Dictation Products
Service Bulletin

Model: BM-60

No.16

Subject: Low Earphone Output Level

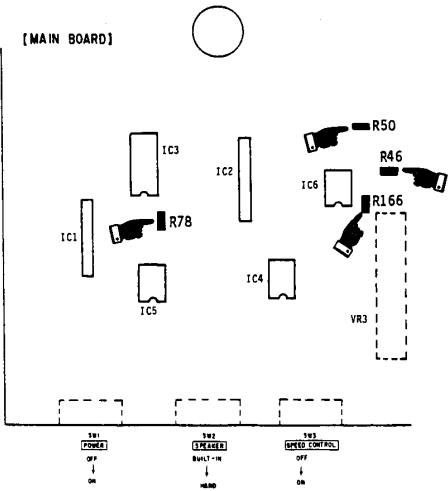
Symptom:
(52) Earphone output level is low when playing back a tape.

Solution: Change the following components value:

R46	1Kohm	-	330ohm	1/8W	1-216-186-00
R50	100ohm	-	27ohm	1/8W	1-216-158-00
R78	15Kohm	-	27Kohm	1/8W	1-216-232-00
R166	1Kohm	-	150ohm	1/8W	1-216-178-00

R46, R50: Earphone Output Level Change at PB mode
R78: Earphone Output Level Change at REC mode
R166: Alarm Output Level Change on Earphone
